LAND USE TYPE III APPLICATION

1010 SE ASH STREET

LU 20-12348 HR

April 24, 2020

PLAN | Lower Level 01

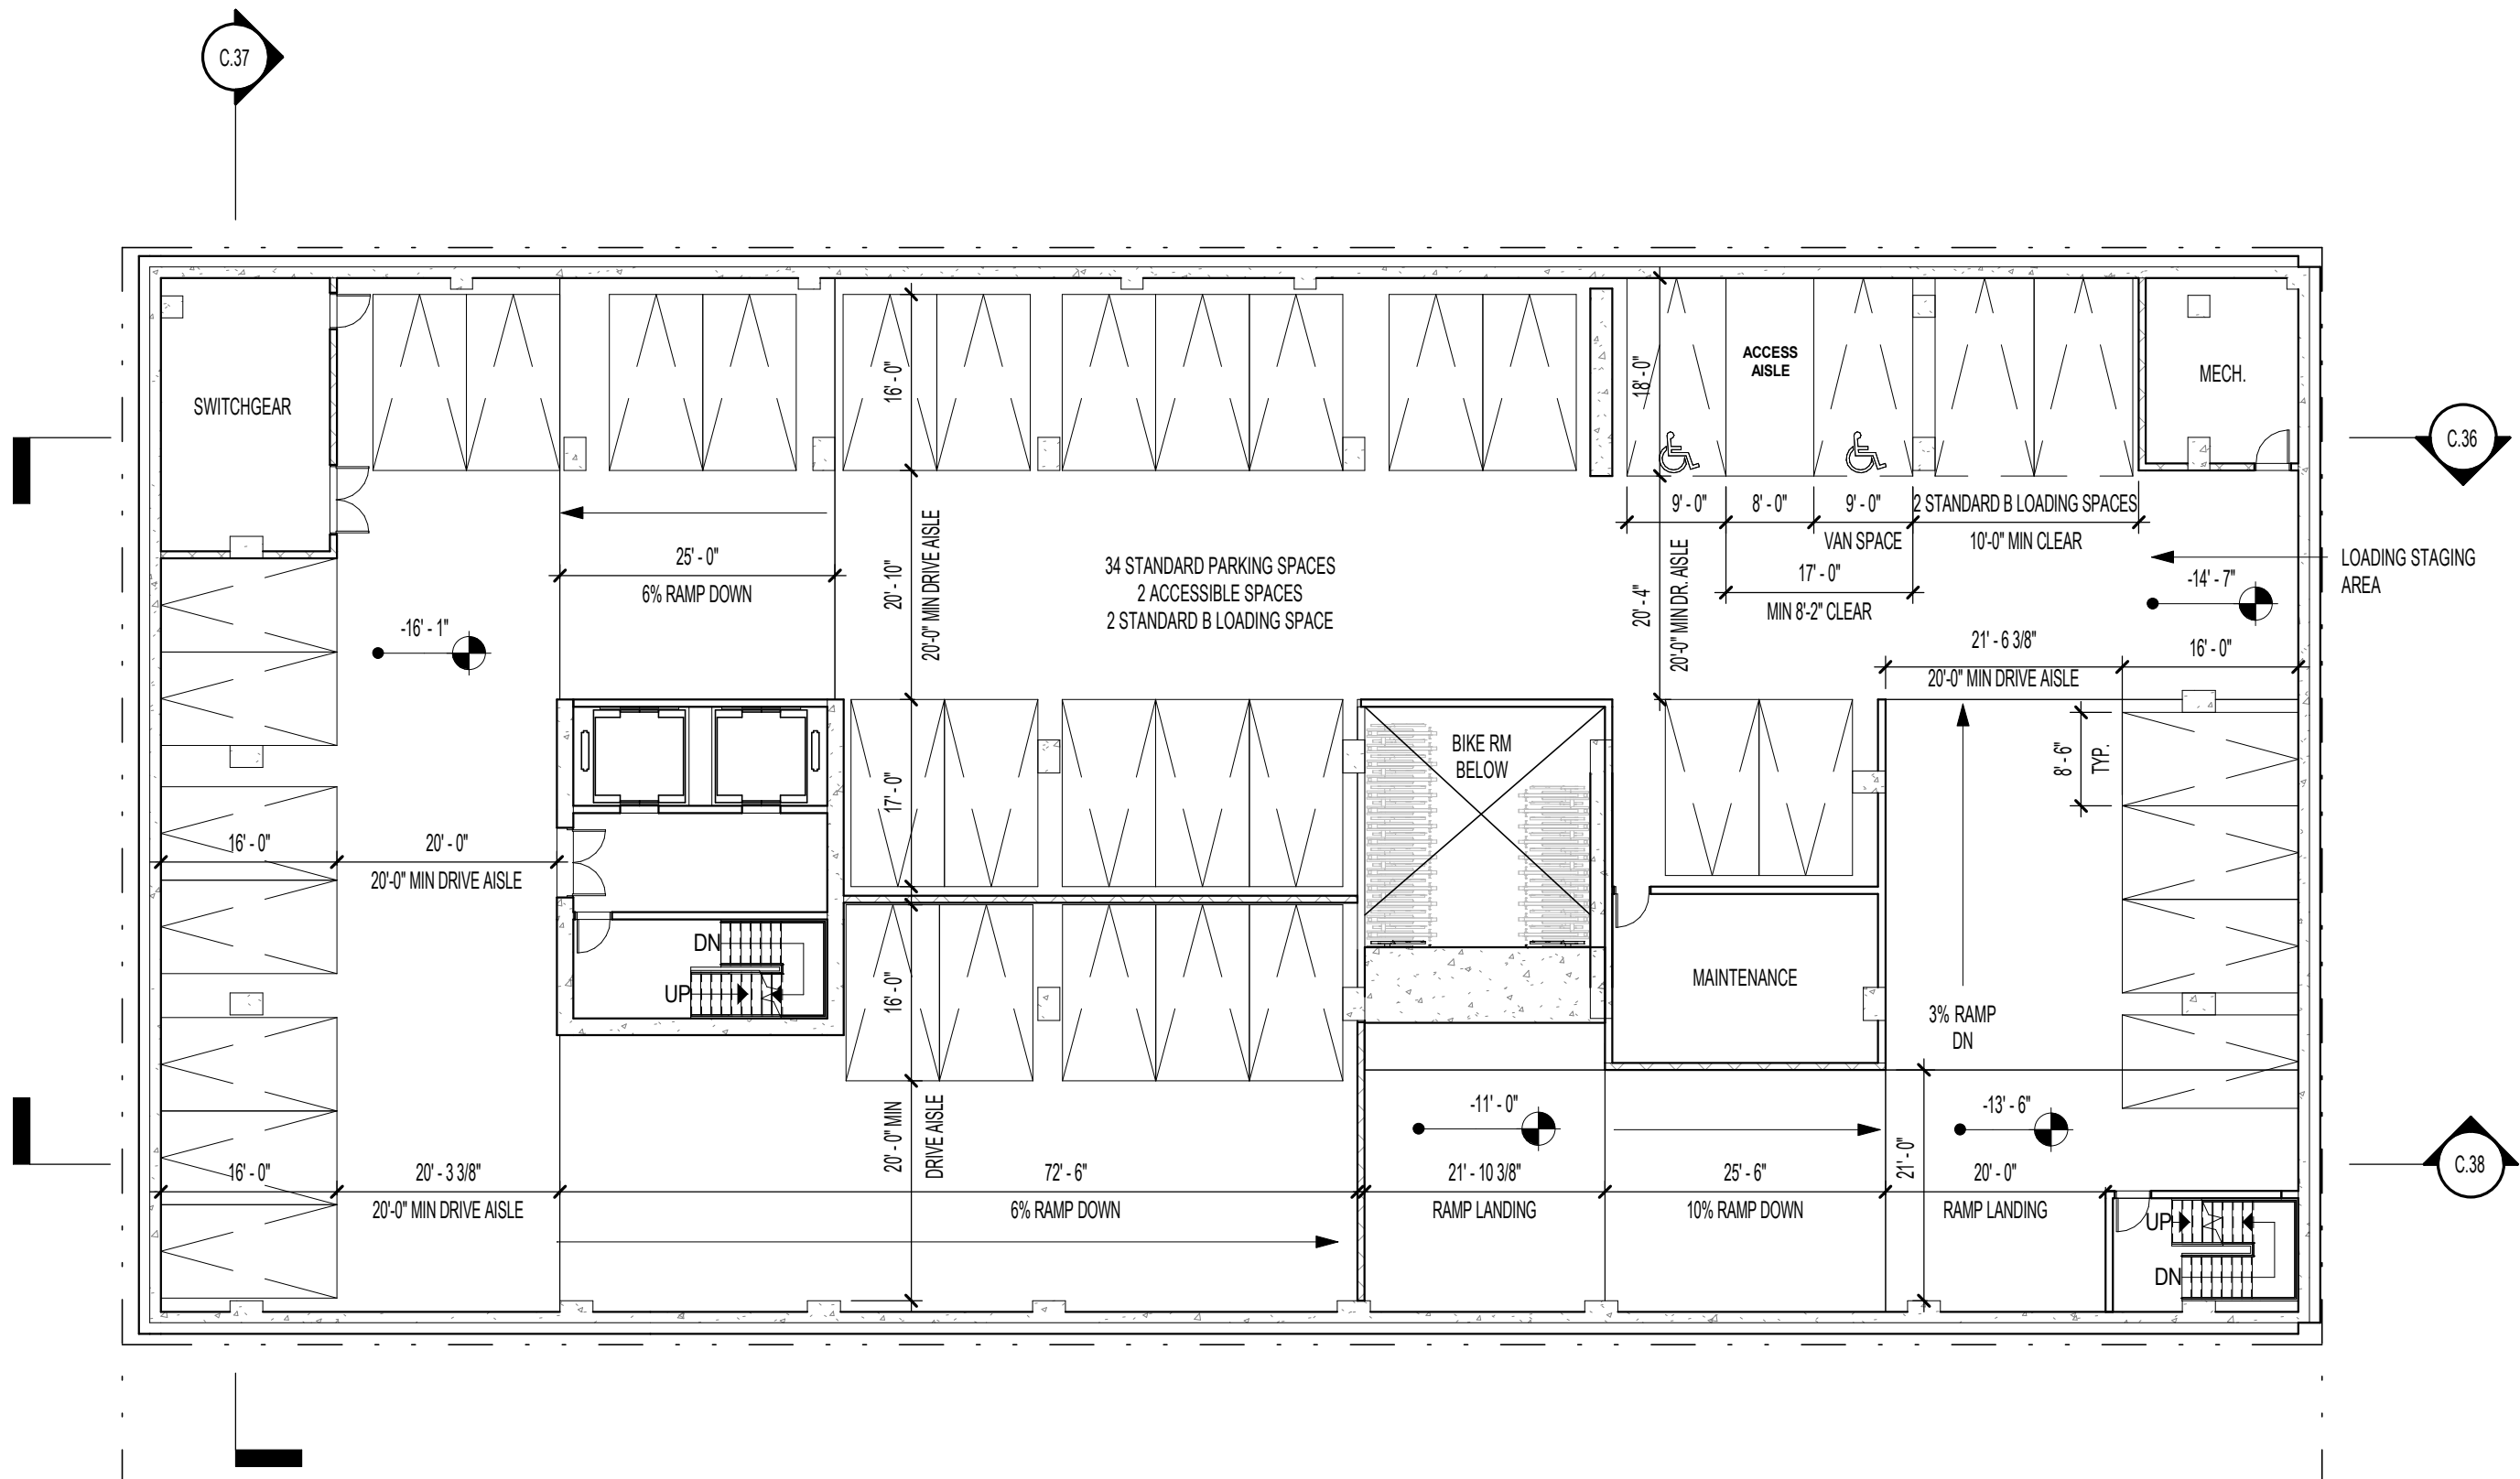
The previously proposed garage door was shown at 18’-8”which is less than the 20’-0” required for aisle width; this would require a Modification to this standard. Staff would not support a Modification to this standard and recommends the garage door width be revised to 20’-0”.

Thank you for providing adequate information to verify the path of travel to the current Type B loading space locations will meet the 10-ft clearance requirements. It appears sheet C78 is also documenting there will be 10’2” of clearance for the upper level of the parking garage. Thank you. When you submit revised floor plans, please label the location of the Type B loading spaces so staff may verify the path of travel meets the 10-ft clearance requirement.

Response: A modification is no longer required, all drive aisles and curb cuts comply - see driveway location exhibit C.42 and lower level plan exhibits C.26 and C.27.

Response: Refer to Lower Level 01 Plan exhibit C.27 for location of Standard B loading spaces.

PLAN | Level 01

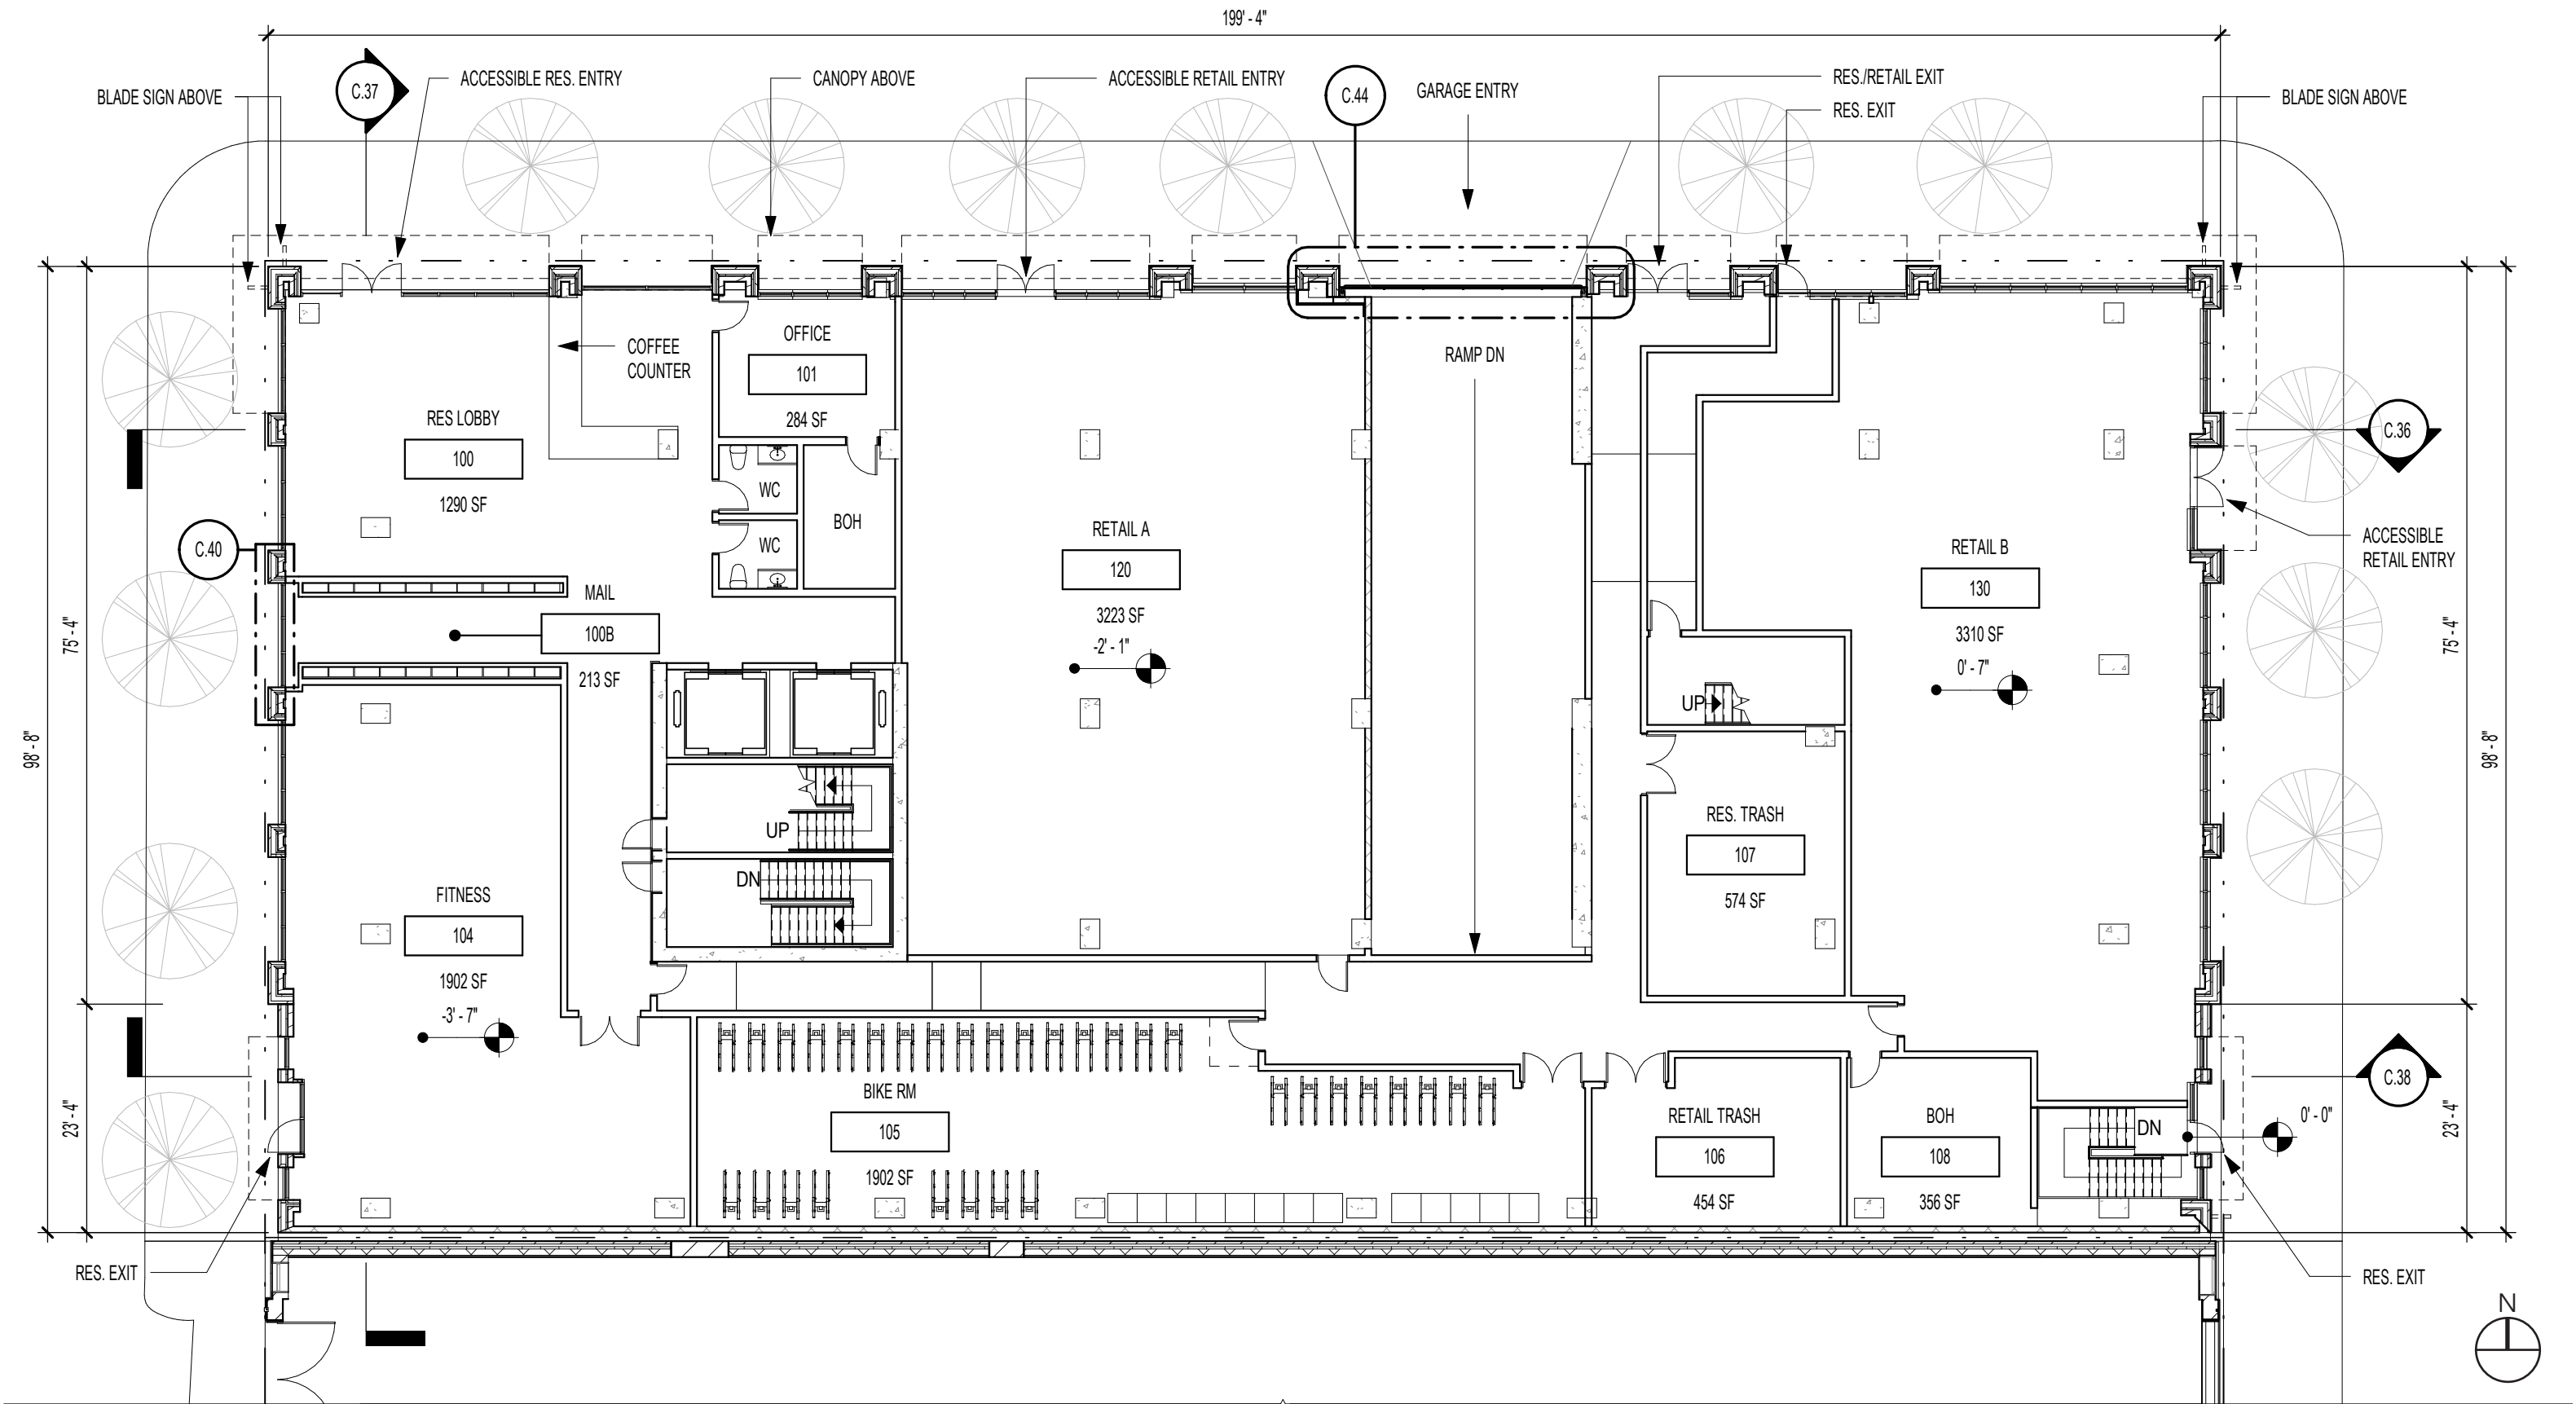
Door swings must be accommodated on private property. Sheets C18 and C68 both show the door on SE Ash Street nearest SE 10th Ave. having a swing which encroaches slightly into the right-of-way. It is possible this is just a drafting issue, as all other door swings are shown as being accommodated on site. Please verify and correct the plans as needed.

Response: Refer to Level 1 Plan exhibit C.28 for revised door swings.

DETAILS | Storefront & Column Base

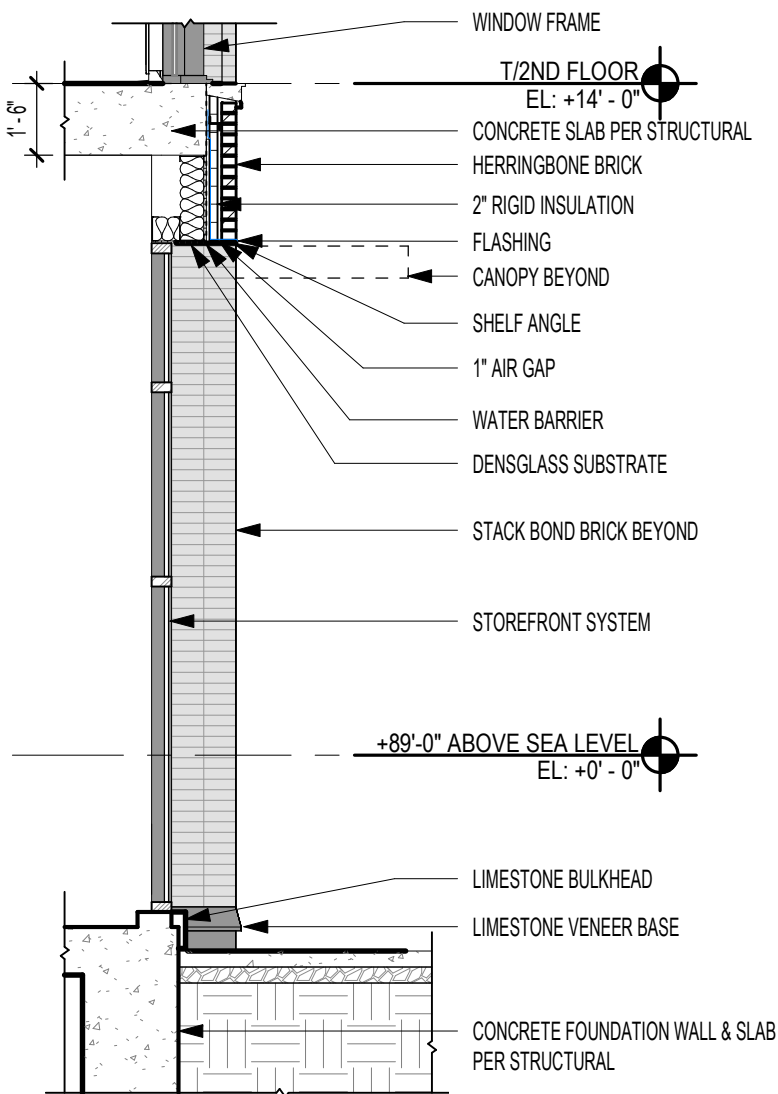
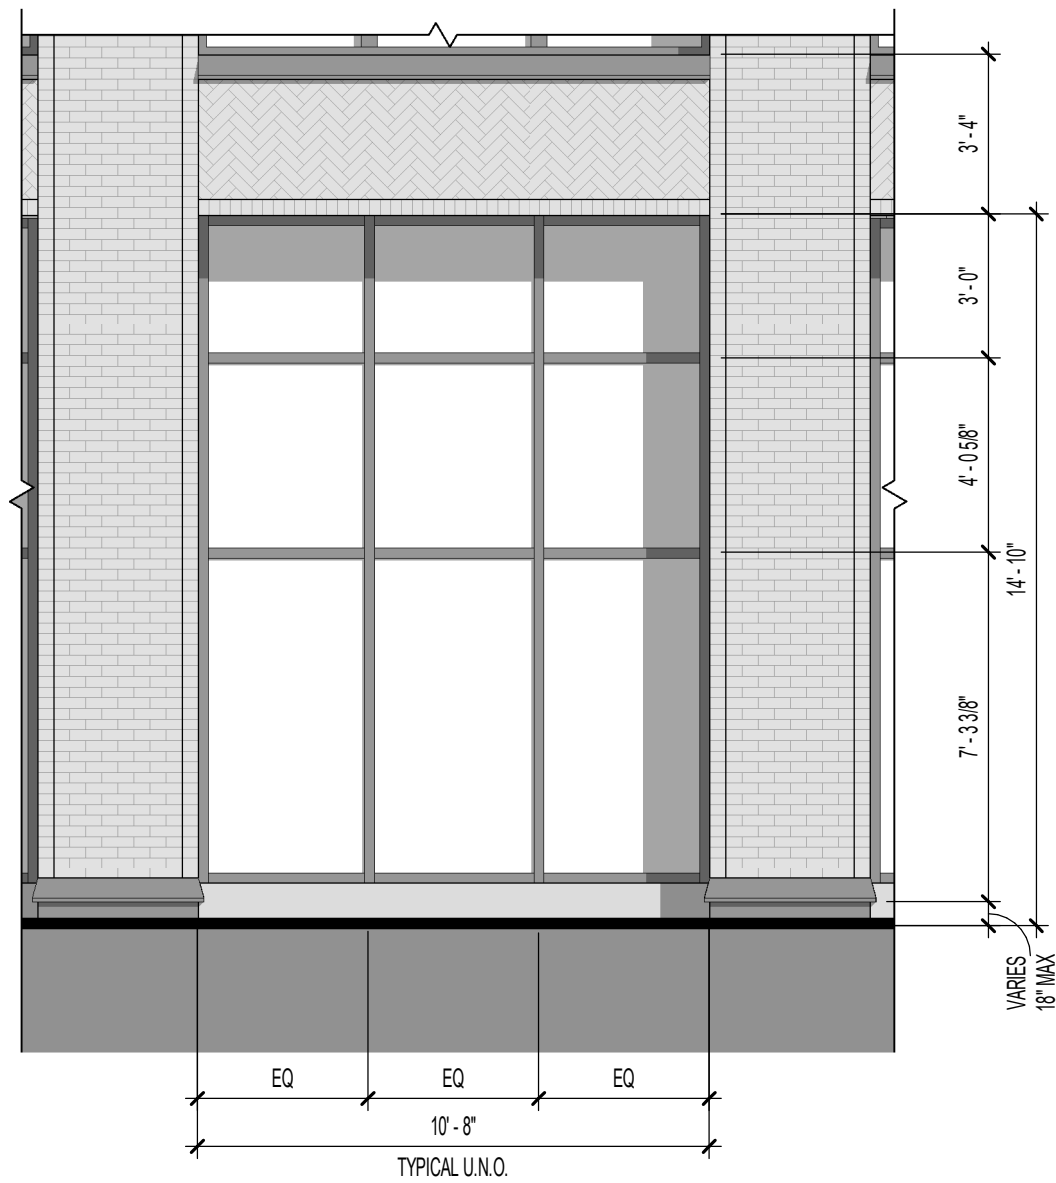
As was suggested at the February 24, 2020 DAR, the storefront windows should include a bulkhead below the windows, generally at the height of the limestone base in order to be more compatible with the Troy Laundry building and to protect the glazing from potential damage.

Response: Refer to Storefront Detail exhibit C.40 for bulkhead detail.
